**MODEL AFFECTED:** 407

**SUBJECT:** SPANNER NUT P/N MS172244, INSPECTION OF

Figure 1. Oil cooler blower assembly

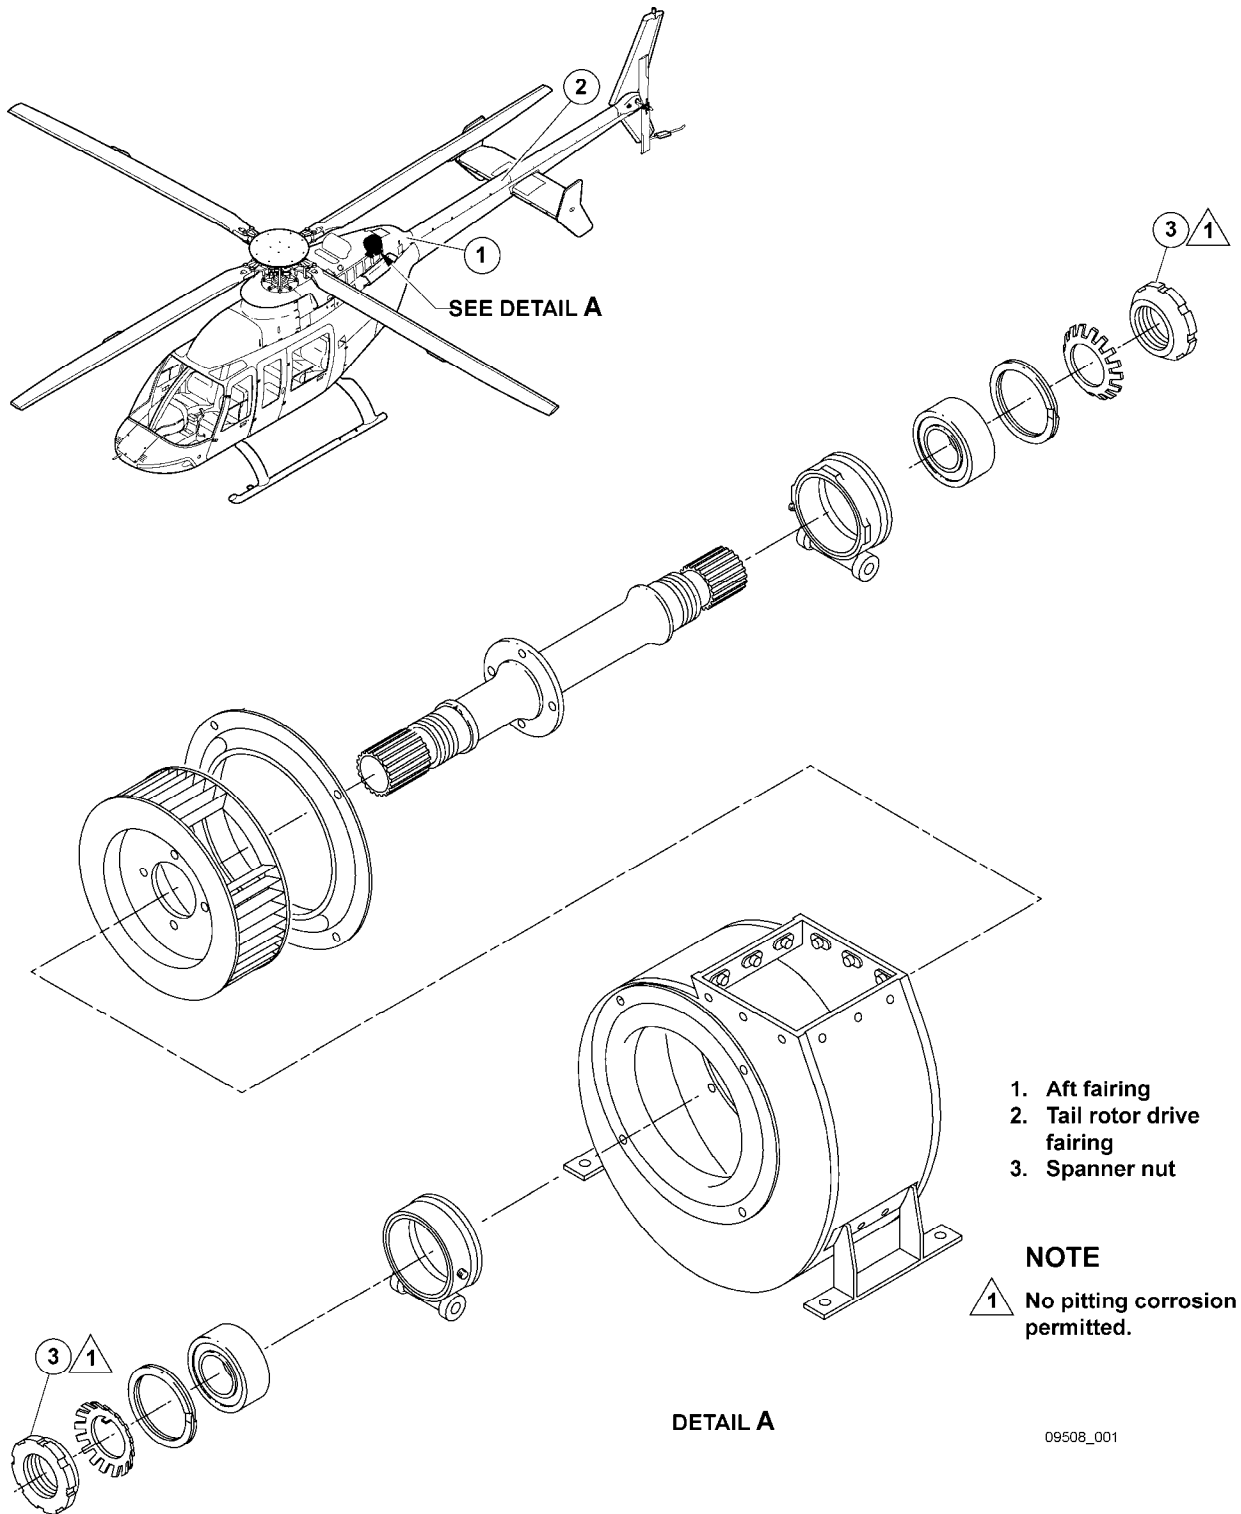
1. Gain access to oil cooler blower shaft assembly (Refer to Detail A, Fig 1).

2. Clean forward and aft nuts (3) using Aliphatic Naphtha (C-305).
3. Visually inspect forward and aft spanner nuts (3) for evidence of corrosion.
  - a. If surface corrosion is found, remove and replace with nut 90-118-4 or phosphate coated nut MS172244 (Refer to BHT-407-MM-7 Chapter 65). If the nut can not be replaced immediately, apply corrosion preventive compound (C-101). Replace the nut when ever convenient.
  - b. If pitting corrosion is found, remove and replace immediately with nut 90-118-4 or phosphate coated nut MS172244 (Refer to BHT-407-MM-7 Chapter 65).
